Title		
REASON UNLEASH BASE		
Size	Document Number	Rev
C	RP-071803-01	F
Date	Friday, July 18, 2003	Sheet 1 of 1

Headset Charger Case

RP-100902-01

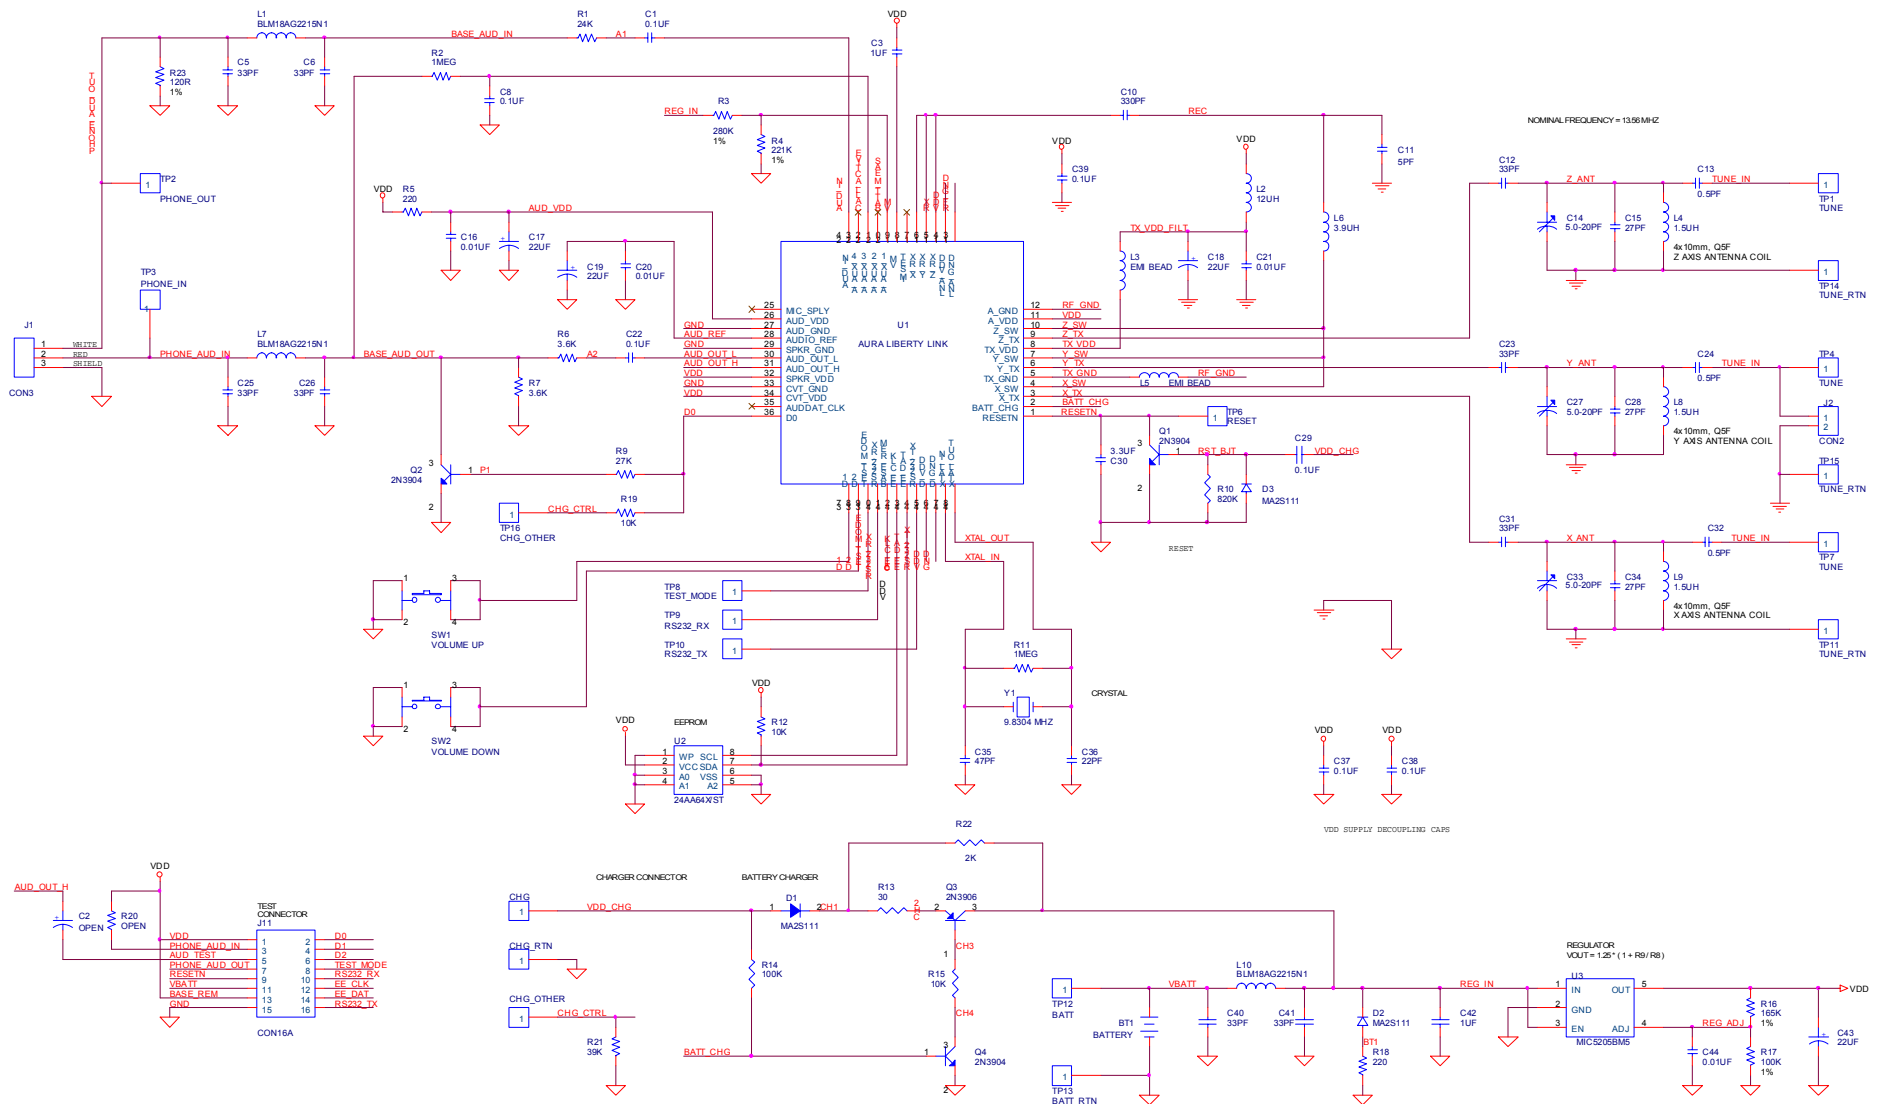
- A: ESD protection on CHG_CTRL. Add Bead to TX_VDD. Remove two 3.9uH from RX CKT. Remove two 330pF from Rx CKT. Short SW pins. Short RX pins. Make R6 15K.
- B: MAKE R6 3.6K
- C: Updated part numbers for Y1, C11, C14, C27, C33, U2, L1, L3, L4, L5, L7, L8, L9, L10. Functionality remains the same.
- D: Updated U2 part number
- E: Schematic change only. Changed R13 value. Added R22.
- F: Changed R9 value. Added R23.
